Service Bulletin

PRELIMINARY INFORMATION

Subject: Tire Pressure Monitor (TPM) Light On and/or Loss of TPM Reading Displayed on DIC

Models: 2013 Chevrolet Camaro - Equipped with BTV (Remote Start) Only
2014-2015 Chevrolet Camaro

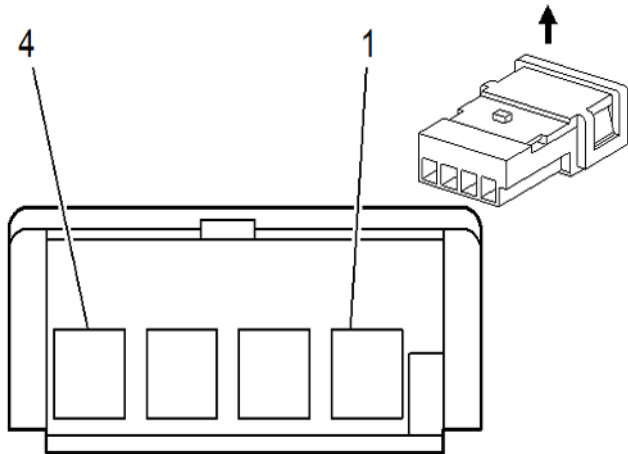
6. Remove the connector from the remote control door lock receiver, shown in the illustration above, cut wires and remove the terminals from the connector.

7. Obtain bulk 0.35 gauge wire and cut 4 leads 2436 mm (8 ft) in length.

8. Crimp the terminal 92899-5 to one end on each lead. Install terminals into each cavity 1 through 4 of the remote control door lock receiver connector shown above.
9. Re-connect the connector to the remote control door lock receiver and route the wires up in the headliner down the driver side windshield garnish molding to the BCM connectors.

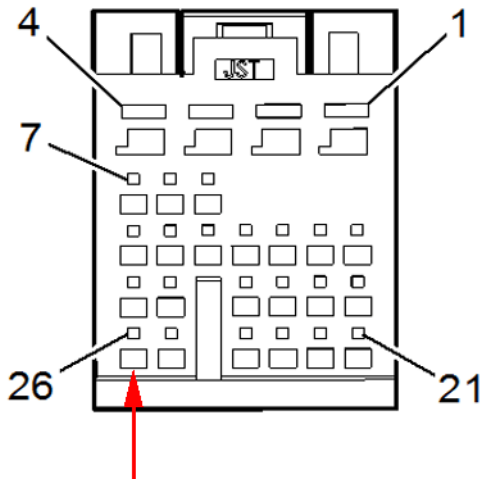
Note: Technicians need to pay attention to the routing of the newly installed wiring harness on the driver side windshield garnish molding, so it will not interfere with the roof rail airbag operation.

K9 Body Control Module (BCM) X1 shown in the illustration above.

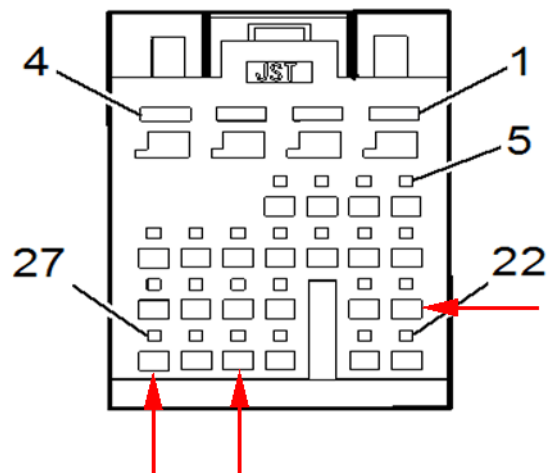
Note: When looking at connectors K9 Body Control Module (BCM) X1 and X2, count the cavities from right to left.

10. Crimp the terminal SNAC-A061T-M2.8 on lead 1 of the remote control door lock receiver. Remove the old terminal before installing the new terminal into cavity 16 of the K9 Body Control Module (BCM) X2 connector, shown in the illustration above.

11. Crimp the terminal SNAC-A061T-M2.8 on lead 2 of the remote control door lock receiver. Remove the old terminal before installing the new terminal into cavity 27 of the K9 Body Control Module (BCM) X2 connector, shown in the illustration above.

12. Crimp the terminal SNAC-A061T-M2.8 on lead 3 of the remote control door lock receiver. Remove the old terminal before installing the new terminal into cavity 26 of the K9 Body Control Module (BCM) X1 connector, shown in the illustration above.

13. Crimp the terminal SNAC-A061T-M2.8 on lead 4 of the remote control door lock receiver. Remove the old terminal before installing the new terminal into cavity 25 of the K9 Body Control Module (BCM) X2 connector, shown in the illustration above.
